BORD NA MÓNA ENERGY LIMITED

Ref: W199-2/Srah080

In relation to Condition 3.17 of the Srahmore Waste Licence, we are seeking to agree a change to this condition, as permitted.

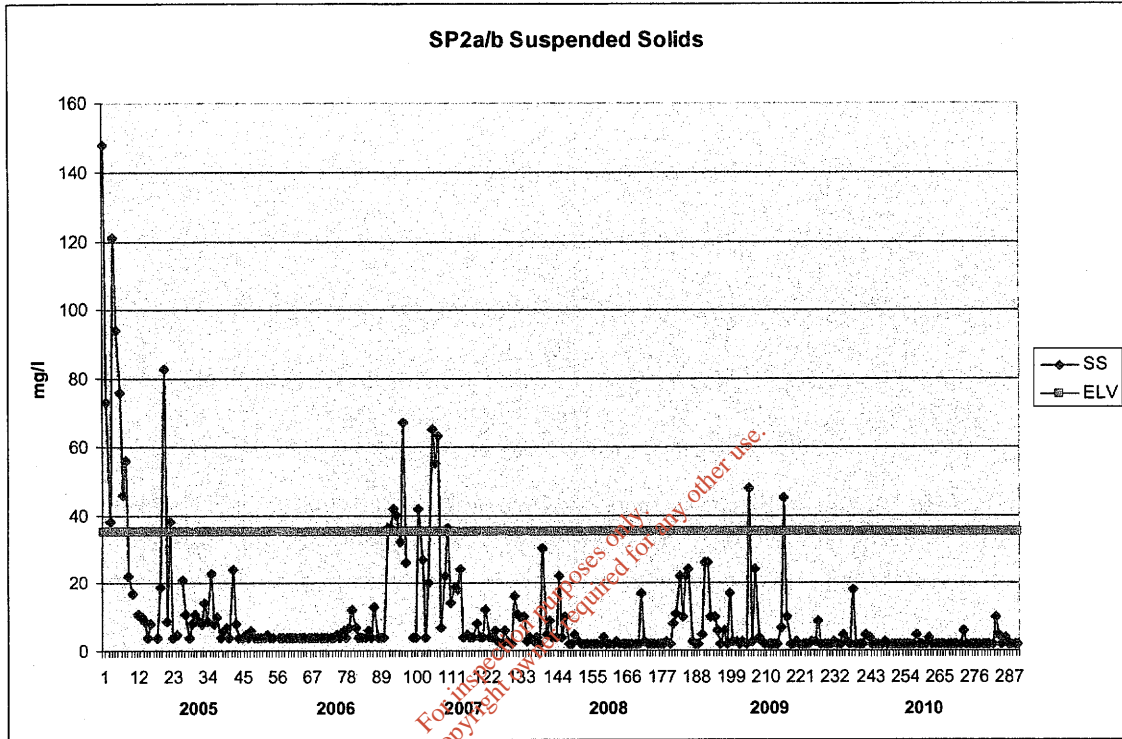
There are five silt pond systems in operation in Srahmore. Three are located and designed to treat run-off from the peat deposition site (S5-1, S5-2 and SP3a & 3b), one is for treating the final effluent from the grit traps and oil interceptors (SP2a/b) and the final one (SP1) treats clean non-process water (see attached map.)

This condition requires the installation of flow restrictors on these ponds, with excess flow diverted to the Controlled Overflow Area (Area 7).

1. In relation to SP1, this is non process water and the installation of a flow restrictor and diversion of the excess water to Area 7 is not possible due to its location.
2. In relation to SP2a/b, this is for treating the final effluent from the grit trap and oil interceptor. This too, is remote from Area 7 and would require the installation of a pump, 500 metres of piping and associated civil works to enable this. This silt pond discharges to the internal outfall before leaving the site via SW4 and receives further treatment in an additional silt pond at SW104, outside the site boundary, before entering the Munhin River.

- While this silt pond system does not have an ELV attached, we have been taking weekly samples from this silt pond system since peat deposition commenced in April 2005 and 93% have been under 35mg/l. Of the 7% that exceeded 35mg/l, 2.7% occurred in the weeks following the completion of the construction phase in early 2005.

- In relation to S5- 1 and S5-2, we can install flow restrictors as these will back up the flow to the swale which discharges to Area 7.
- In relation to SP3a and b, there is a flow restrictor in the swale box which has been manually utilised since 2005, to divert stormwater to area. This is at the 525mm dia pipe (see map) and can be set to achieve the required design flow.

In summary, we are requesting that the requirement to install flow restrictors to all silt ponds be restricted to a requirement to only install flow restrictors on silt ponds where the restricted water can be conducted to the controlled over flow area 7, which would be S5-1 and S5-2. There is a restrictor already in-place for SP3a/b.
